Telephone Inquiries:
MS P EMMETT
File No: 25-2010-8-1
Parcel No: 43644
Your Ref: MP 10_0153

Re: **Proposed: Northbank Enterprise Hub MP 10_0153**
Property: LOT: 1001 DP: 1127780
365 Tomago Road TOMAGO

Reference is made to the Department's letter dated 10 September 2011 requesting comments on the Environmental Assessment (EA) of the above project. Council has previously provided comments on the proposal in letter's dated 4 February 2011, 22 March 2011 and 2 February 2012. Council has significant concerns with the application which are discussed in detail below.

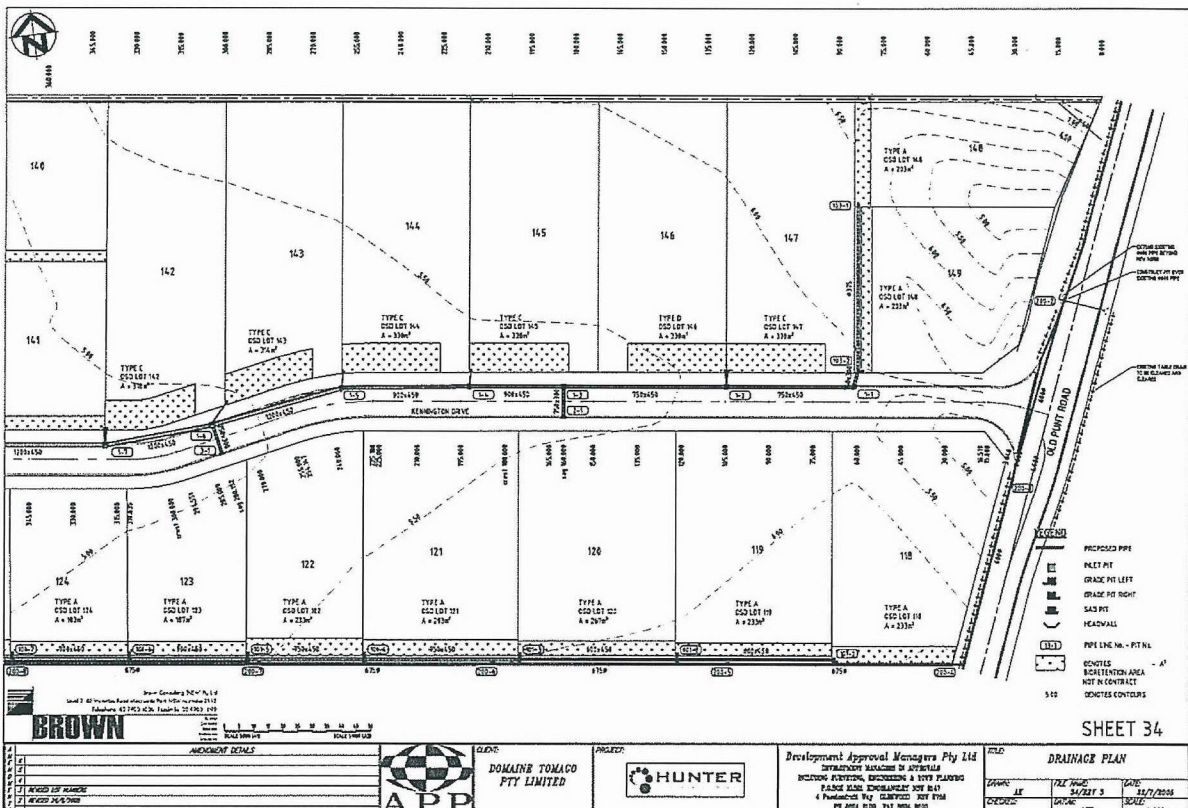
Council objects to accepting the drainage system as proposed due to a number of factors. These include, but are not limited to:

1. The system is not economically maintainable due to the excessive number of small drainage structures required of a flat site.
2. Insufficient preliminary engineering plans provided to assess what structures are proposed. i.e. what is the 'above ground GPT' constructed of and what does it look like? How can Council consider the safety and risk associated with a structure where there is insufficient detail?
3. Some proposed design features such as placing water quality (3 month flow treatment) within the high flow (100yr) channels make the system susceptible to damage and increased maintenance costs

Project NORTHBANK ENTERPRISE HUB MASTERPLAN TOMAGO RD TOMAGO	Drawn by PARKS, AMENITY & VIEW ANALYSIS
C 011 NORTHBANK ENTERPRISE HUB Pty Ltd	Scale Date 2009/01/22 10:58 AM Drawn by MM
	Project Number N21618
	Drawn by DA05
	Map C

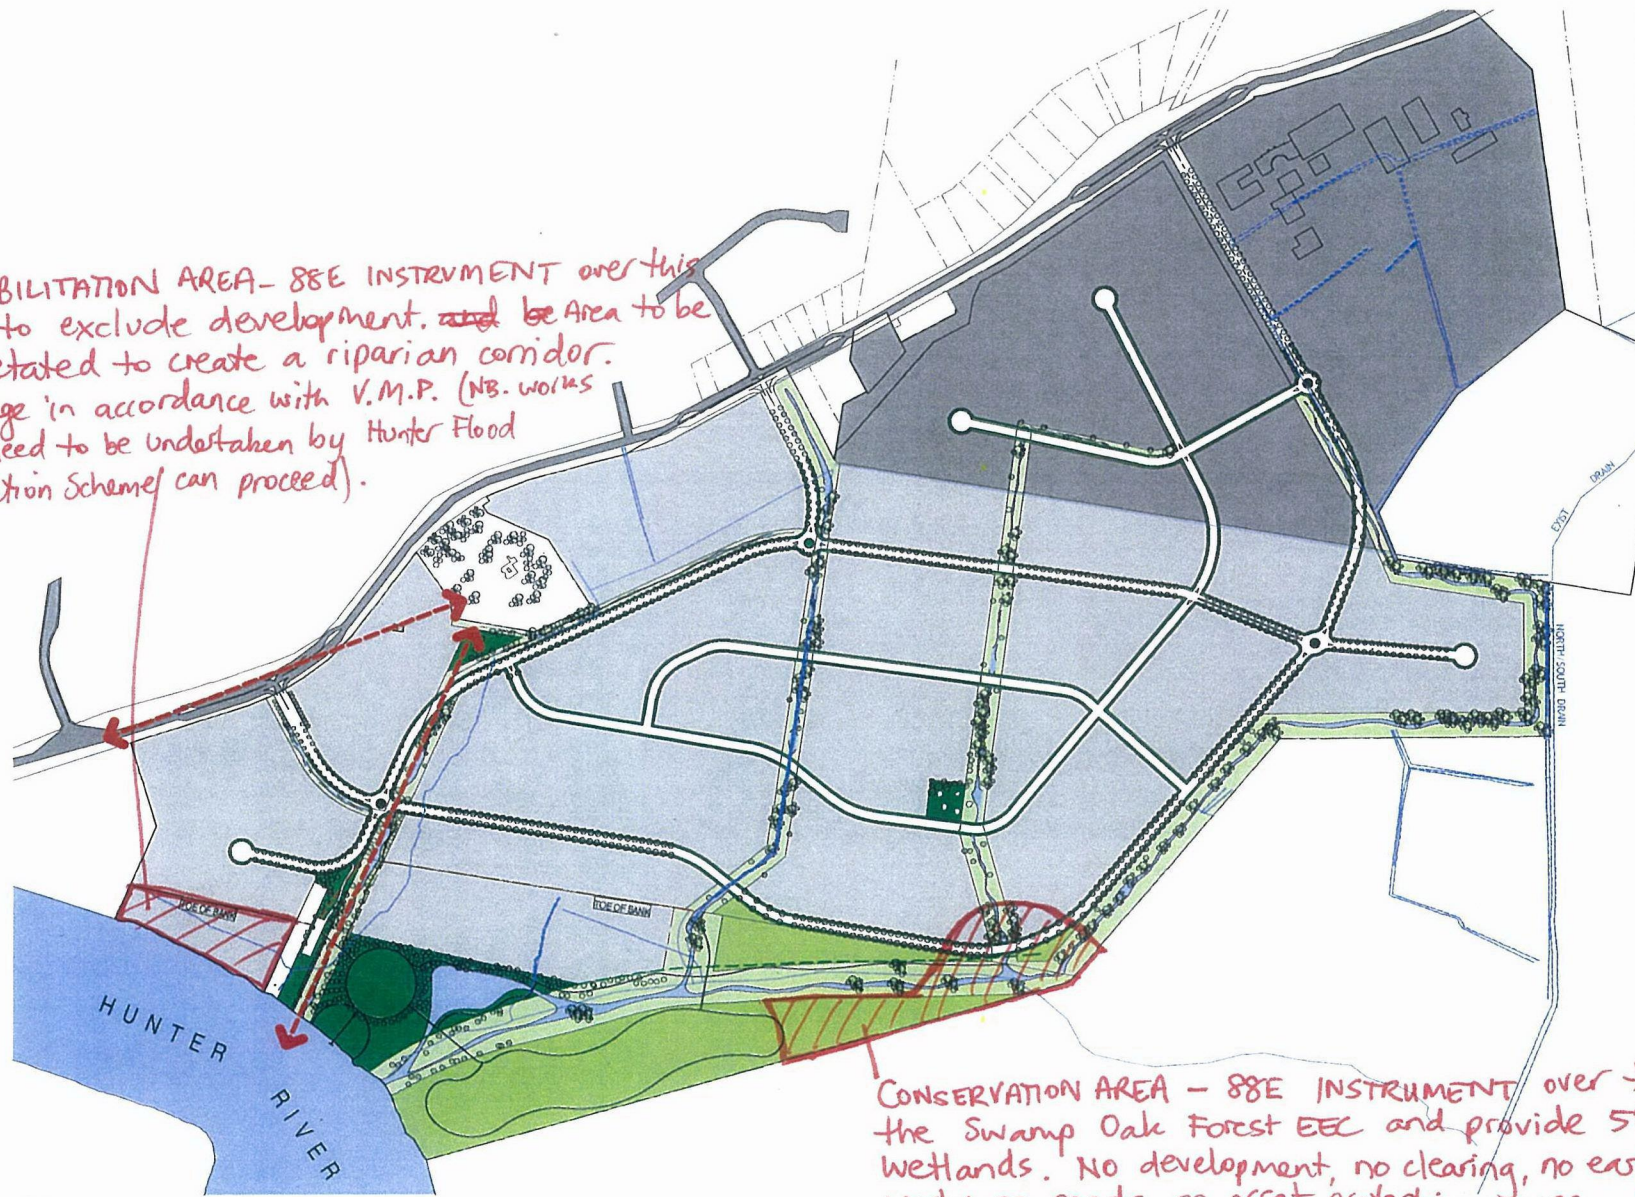
Due to no variations being made to the layout, Council requires that an 88E Restriction as to User areas is incorporated into any approval. These areas are those which Council has labelled the 'Conservation Area' and 'Rehabilitation Area'. Please see marked up plan, and conditions in Attachment 1 which relate to the protection of the SEPP14 Wetlands and a 50 metre buffer and creation of a riparian corridor along the Hunter River.

REHABILITATION AREA- 88E INSTRUMENT over this area to exclude development, and be Area to be revegetated to create a riparian corridor. Manage in accordance with V.M.P. (NB. works that need to be undertaken by Hunter Flood Mitigation Scheme can proceed).

CONSERVATION AREA - 88E INSTRUMENT over this area to protect the Swamp Oak Forest EEC and provide 50m buffer to SEPP14 wetlands. No development, no clearing, no earthworks, no drainage works, no roads, no asset protection zones. Manage in accordance with V.M.P.
